# ARCHITECTURAL REVIEW BOARD

PROPOSAL: To develop a 17-story office complex in the C-3 zone.

LOCATION: 921 "L" Street

APPLC. NO. 79-47

PARKING 2/  
GROUND  
FLOOR LEVEL

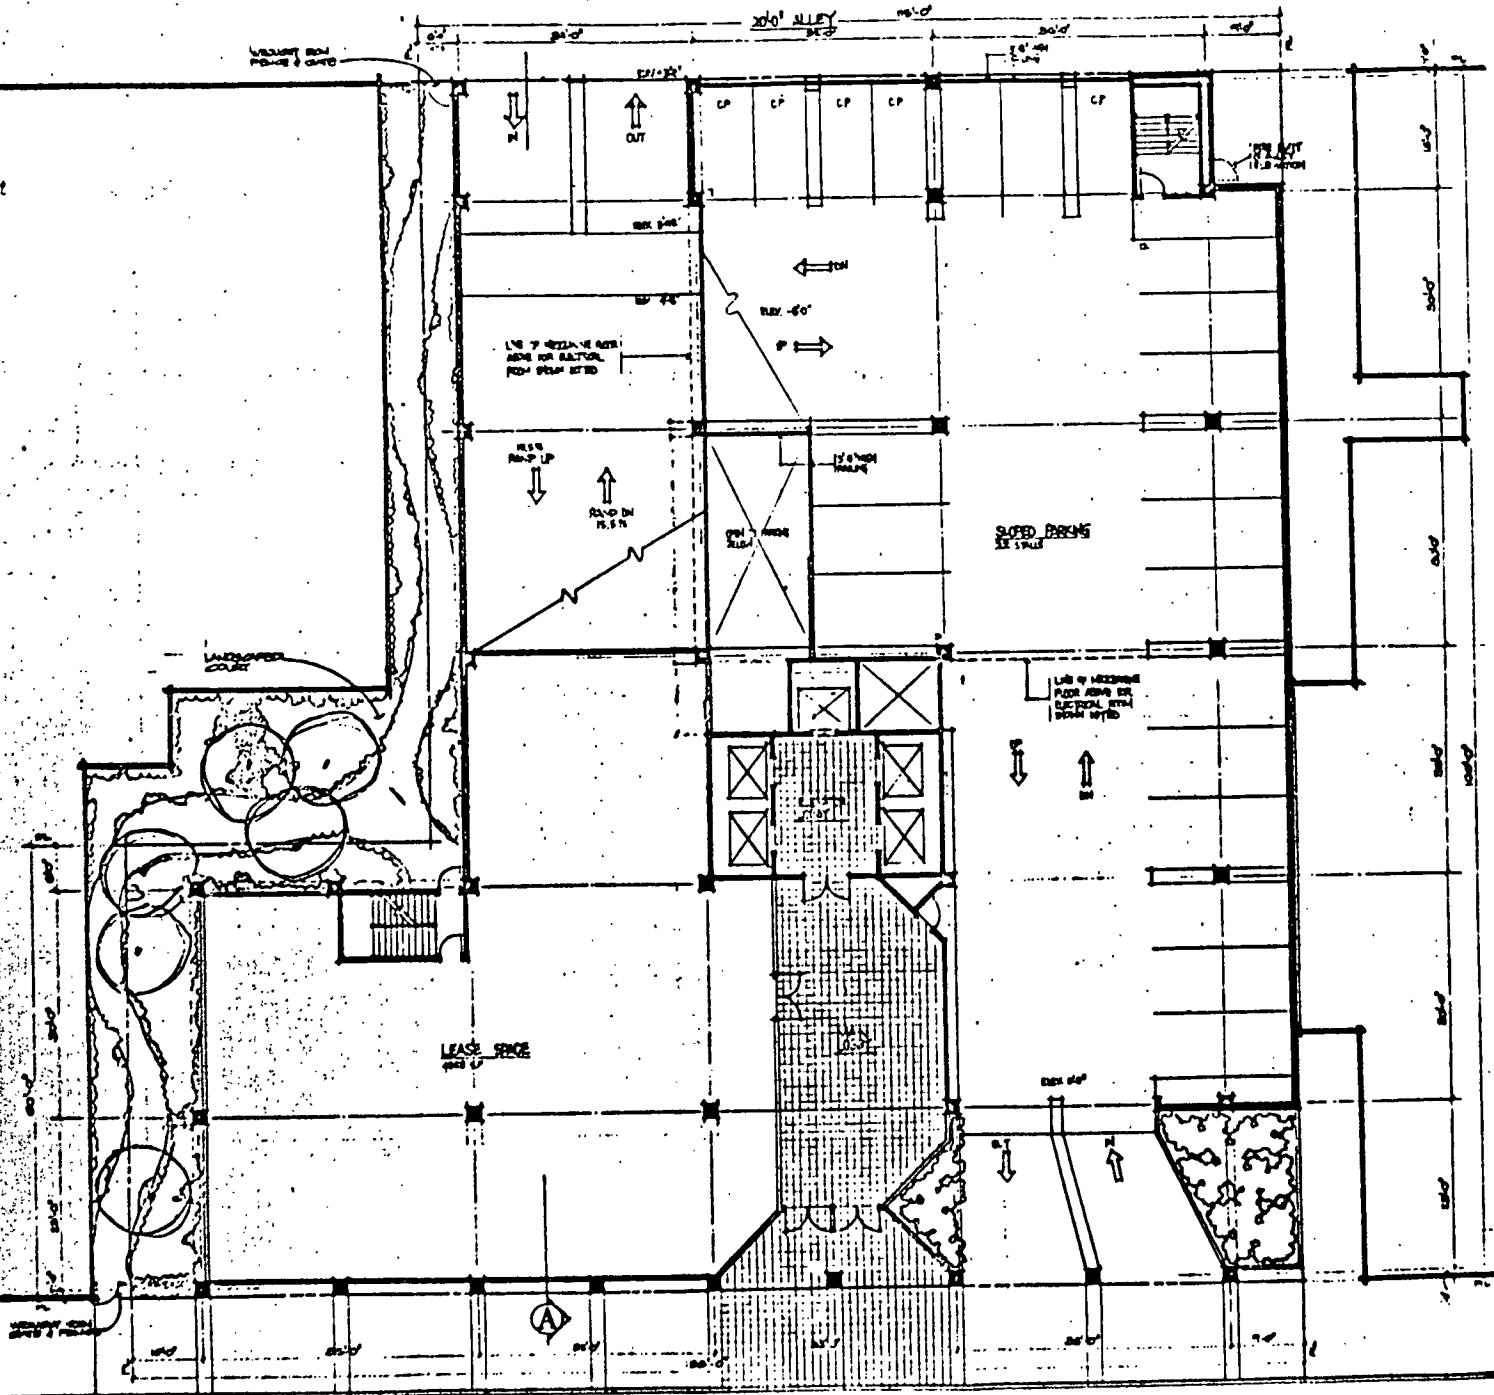
The staff suggests the window front along "L" Street be recessed and de-

designed with a landscaping strip. This would soften the area between the concrete sidewalk and the structure. The staff also suggests the applicant design bicycle storage facilities within the project. The City Traffic Engineer has the following comments:

1. For the parking lot driveway on the alley, they should provide some sort of flare similar to the one at the United California Bank so as to allow for turning and for visibility for cars entering and leaving the parking lot.
2. The need for a large flare can be reduced to some extent by requiring no parking on the north side of the alley opposite driveway and 30 feet on each side, (I believe that this will conflict with an existing loading zone.) plus the installation of a mirror on the north side alley wall.
3. The driveway onto "L" Street will probably require a pedestrian warning system, depending on how the ramps are constructed. The driveway's design will require review and approval by our Division when we issue a driveway permit for this location. These comments do not address the details of driveway design for both the alley and "L" Street.

1. The window fronts along "L" Street shall be recessed and a raised planter strip shall be designed along "L" Street.
2. Subject to complying with Special Permit conditions, P-8475.
3. Signs shall be compatible with the structure and be reviewed and approved by the staff.
4. Bicycle storage facilities shall be provided within the project.
